Re: F. HOEFLICH DITCH IMPROVEMENT PROJECT NO. 142

ADDENDUM #1

RE: F. HOEFLICH DITCH IMPROVEMENT PROJECT NO.142 – ADDENDUM #1

MAIN PROFILE STA. 0+00 - 28+00

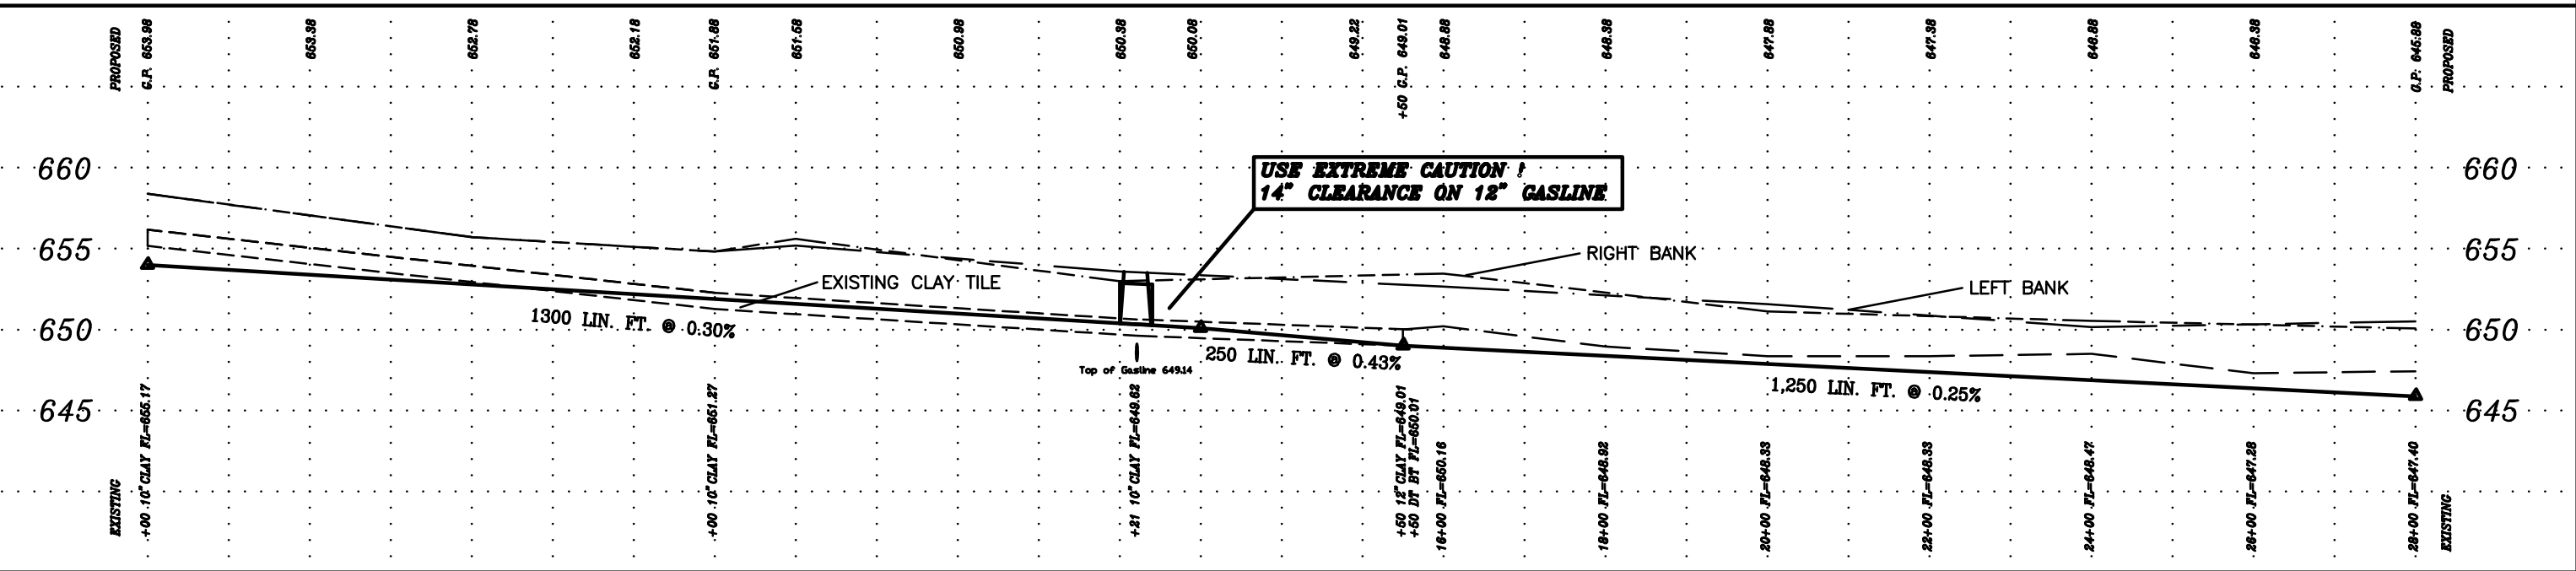
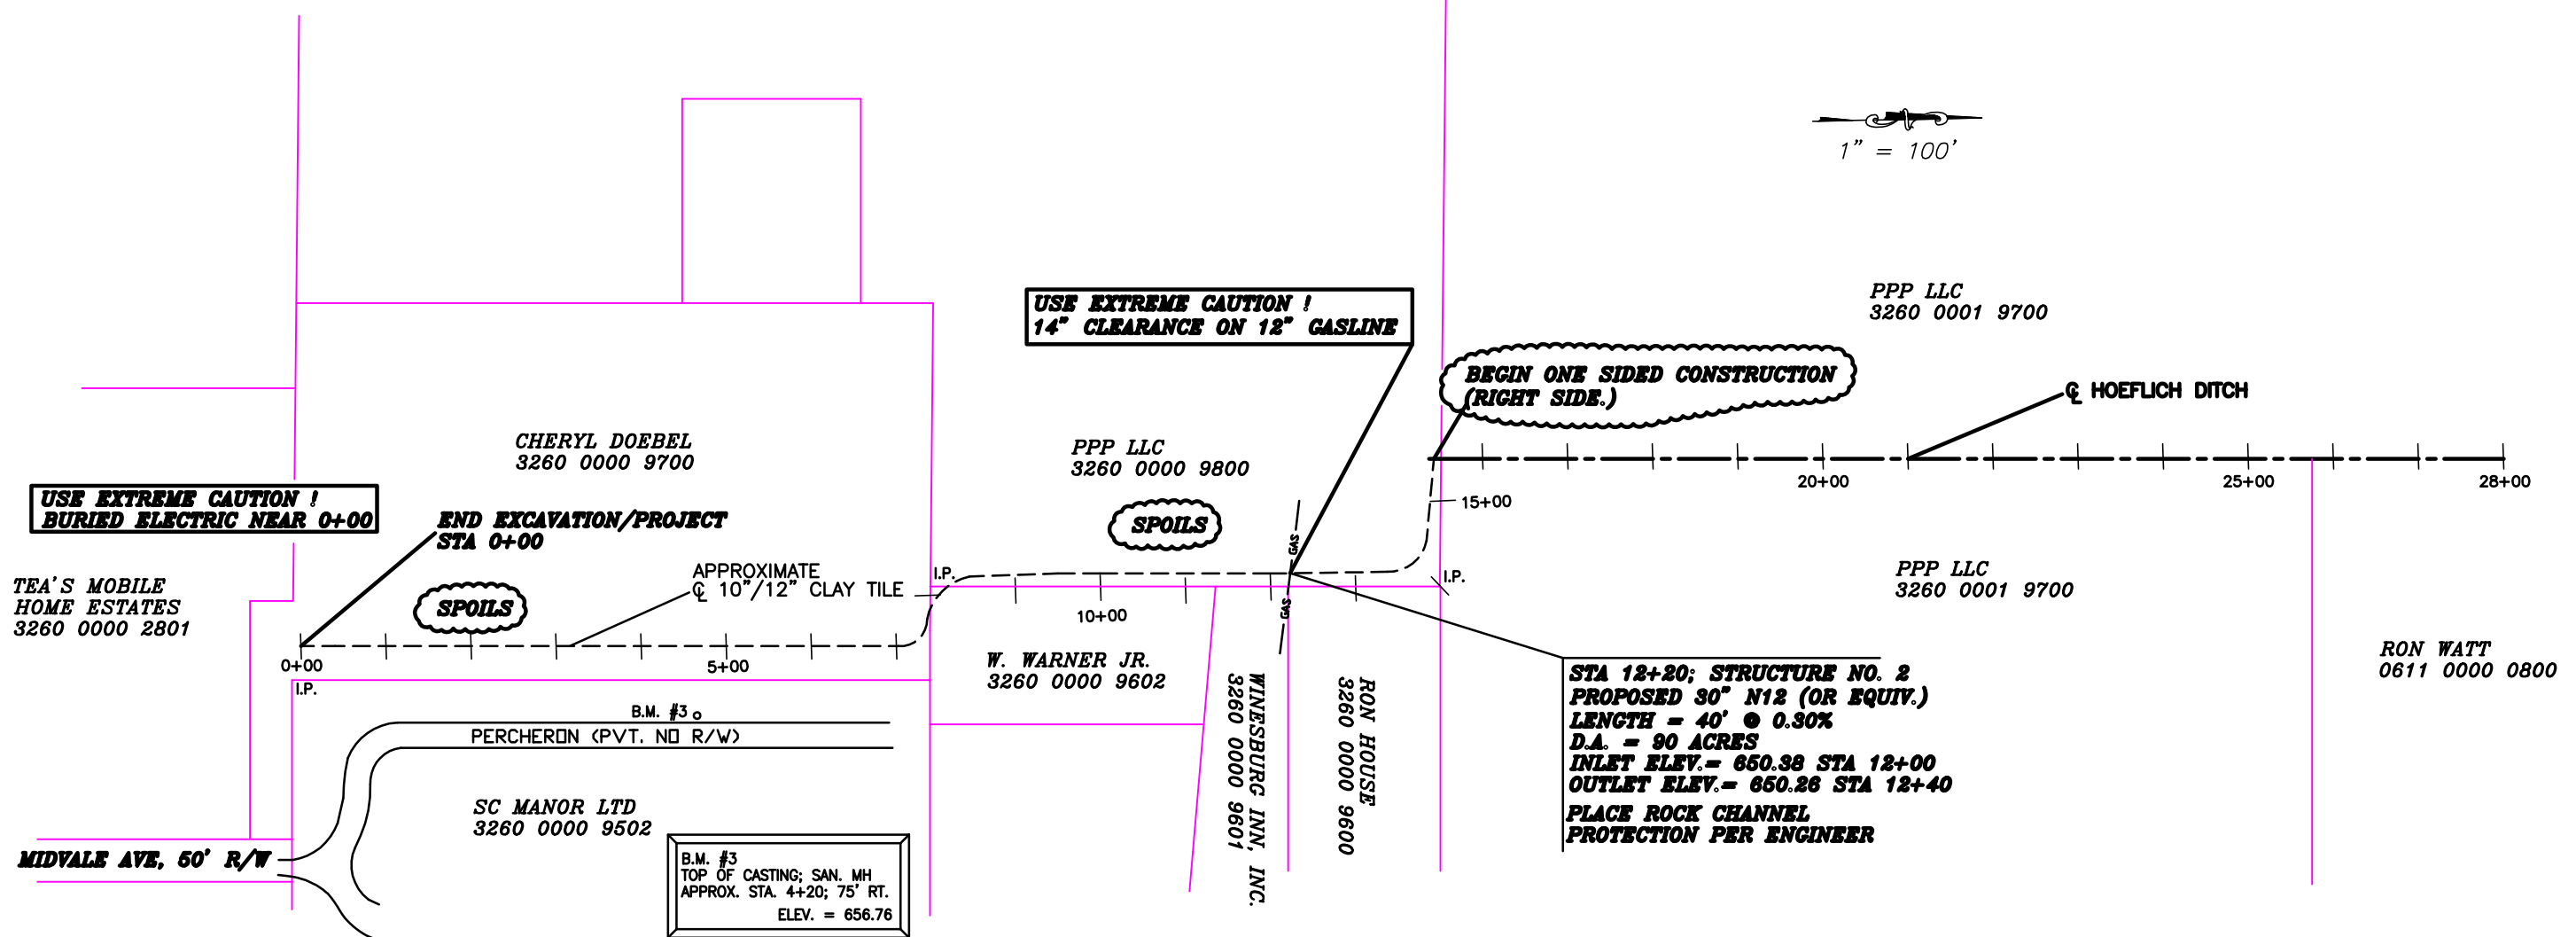
- 7) **NOTES ON SHEET 3/9**
 - a) Please replace sheet 3/9 of the Plans with the revised sheet **3/9 “Revised 2/19/15”**
 - b) The **clarification** note was added. **Begin 1 sided construction (right side)** note was added. The side where the **spoils** are to be placed was noted.

- 9) **CLARIFICATION NOTE**
 - **The contractor will not be responsible for picking up individual pieces of the removed clay tile. The tile shall be crushed and leveled with the spoils. As noted in the Plans sheet 3/9.**

NOTE: THE CONTRACTOR WILL NOT BE RESPONSIBLE FOR PICKING UP INDIVIDUAL PIECES OF THE REMOVED CLAY TILE. THE TILE SHALL BE CRUSHED AND LEVELLED WITH THE SPOILS.

MAIN PROFILE STA. 28+00 - 56+00

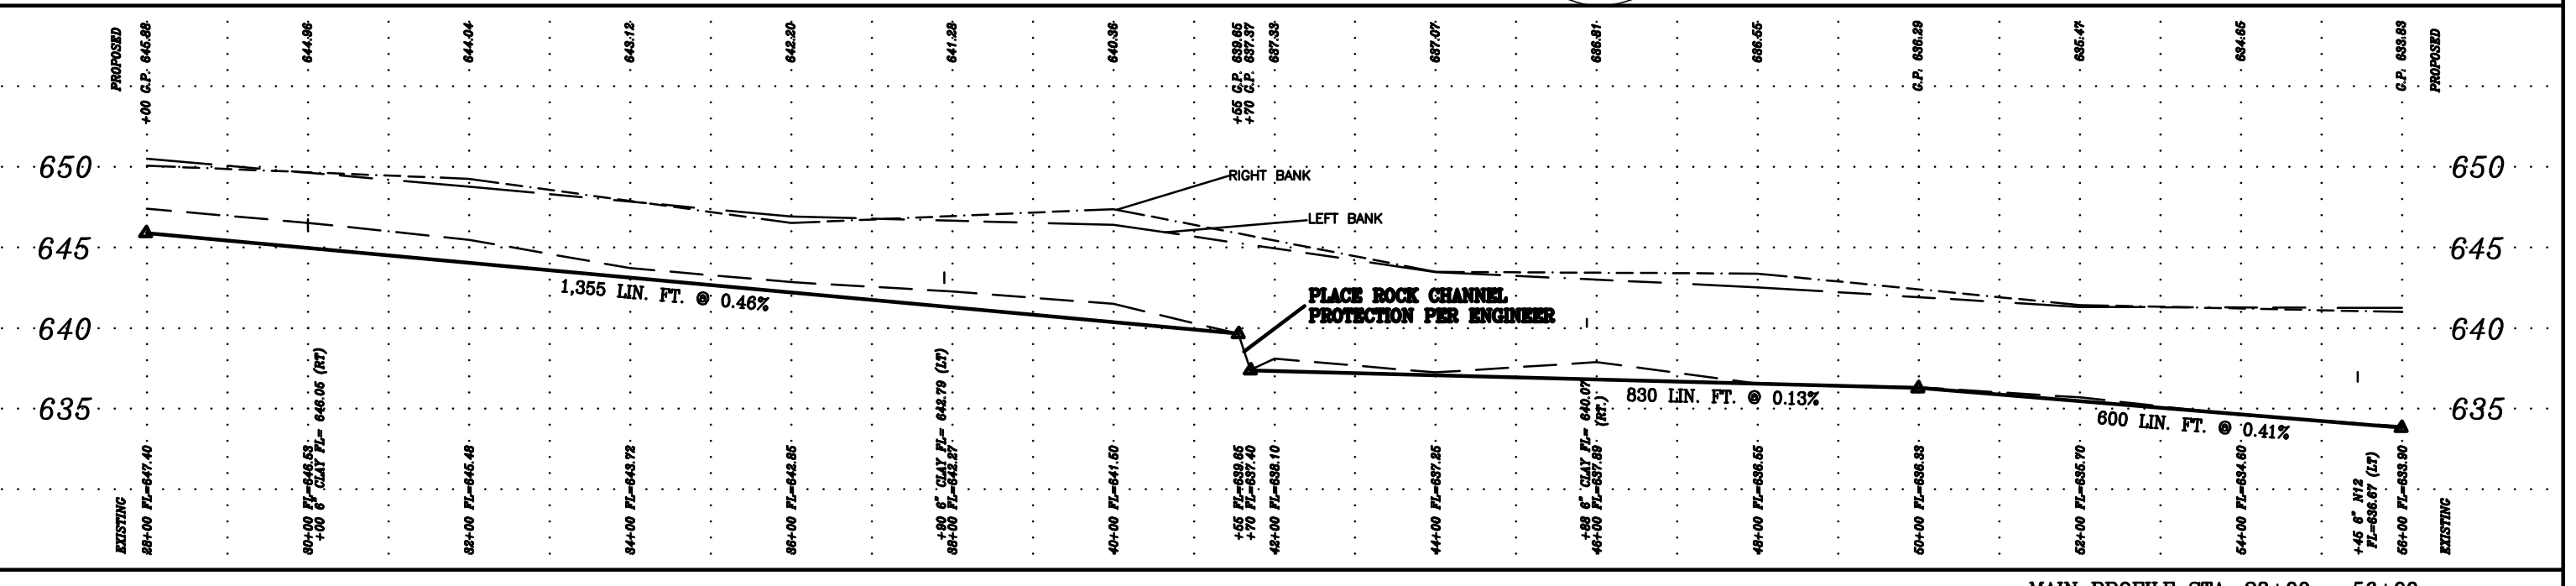
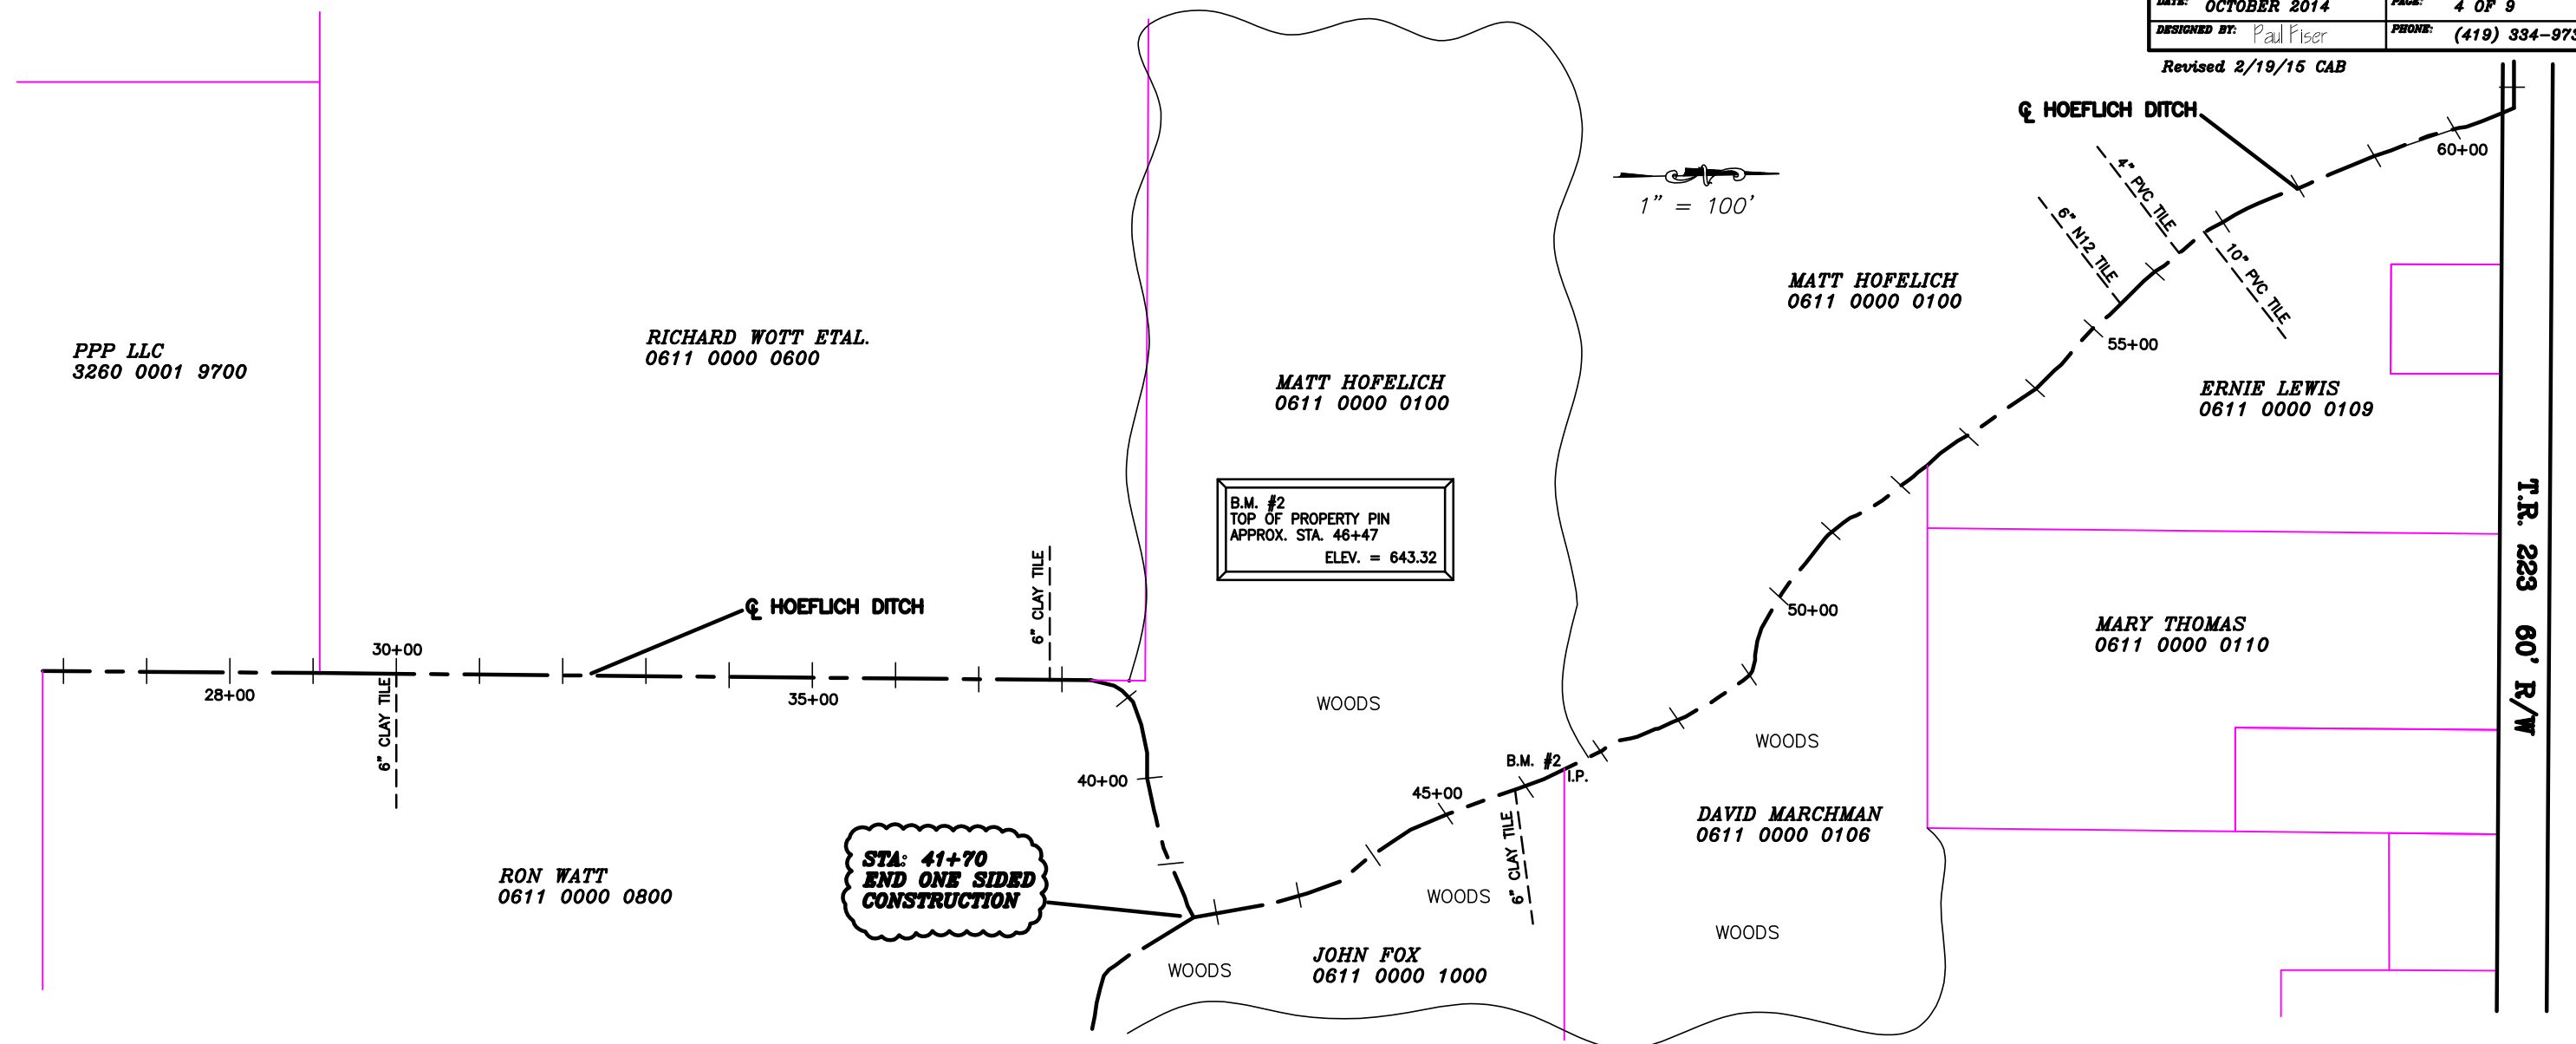
- 8) **NOTES ON SHEET 4/9**
 - a) Please replace sheet 4/9 of the Plans with the revised sheet **4/9 “Revised 2/19/15”**
 - b) The **end one sided construction** note was added.
